RESOLUTION
R 63-16

VILLAGE OF LOMBARD CHANGE ORDER

PROJECT NAME: Roosevelt Road Watermain Lining (West Contract) PROJECT NO.: WA-12-01/03
 LOCATION: West Roosevelt Road CHANGE ORDER: 01
 CONTRACTOR: Sheridan Plumbing & Sewer, Inc. DATE: 9/6/2016

DESCRIPTION OF CHANGE ORDER: (1) Install a 6'-diameter vault in lieu of the proposed 5'-diameter vault for the proposed 16" insertion valve at northwest corner of Roosevelt Road and Highland Avenue. (2) Connect existing 2" service, for Heritage Cadillac, to existing 10" watermain on the south side of Roosevelt Road. (3) Set-up an additional lane closure for northbound Finley Road to remove a 10"x8" reducer.

72 STA. 811+04, 101' LT
 VALVE AND VAULT, 5'-
 16" INSERTION VALVE
 50 SQ FT SIDEWALK RE
 50 SQ FT PCC SIDEWALK
 8 SY TOPSOIL, FURNISH
 8 SY TOPSOIL, FURNISH AND PLACE 4"

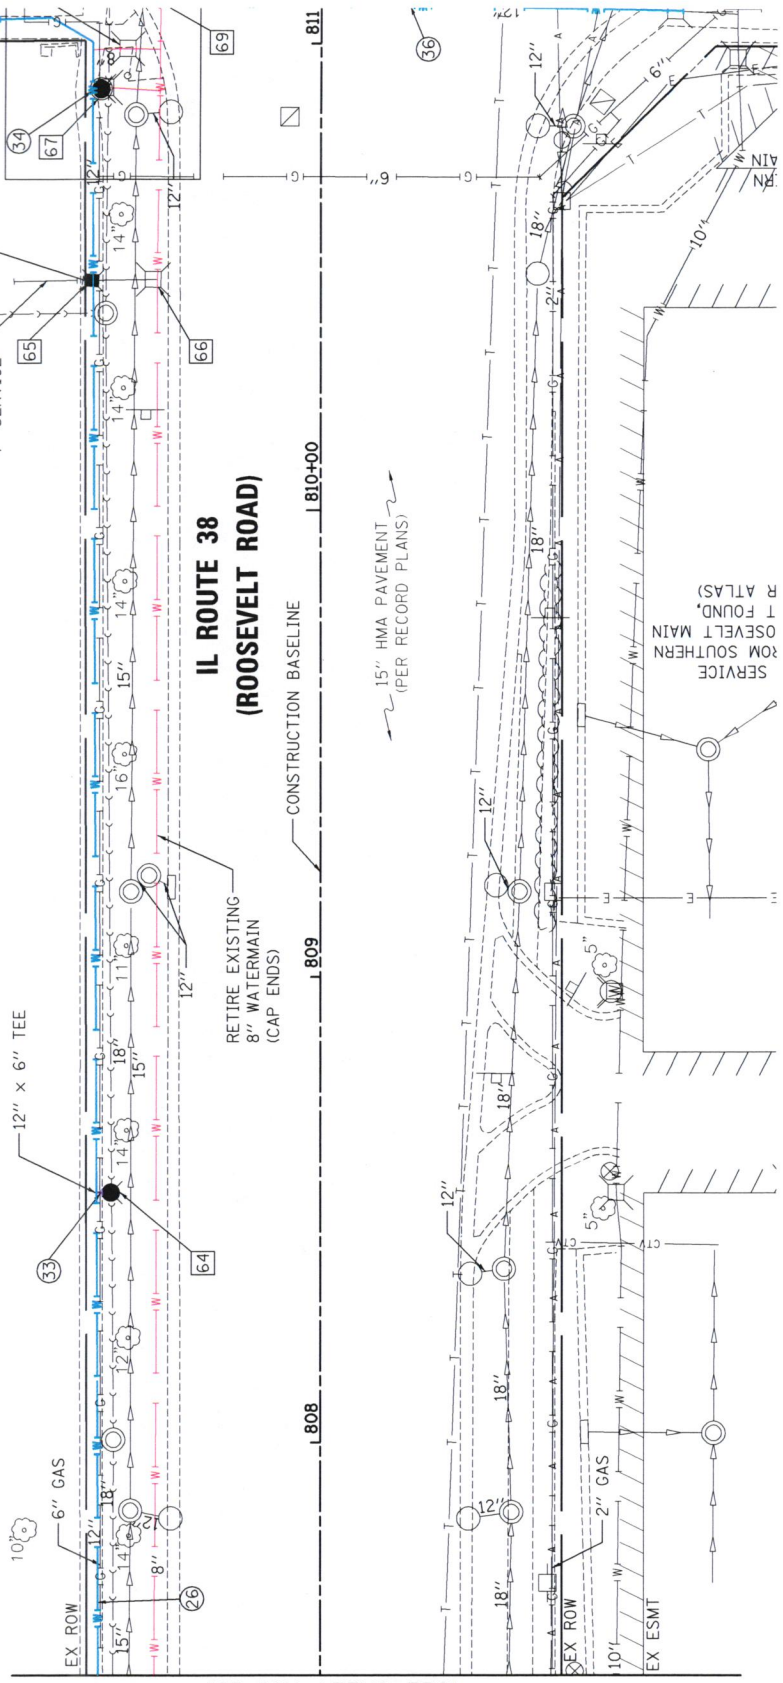
PROJECT: Installation of a 72" "split-bottom" vault for the 16" insertion valve ✓
 → This is in lieu of a 60" split-bottom vault (proposed per plan).
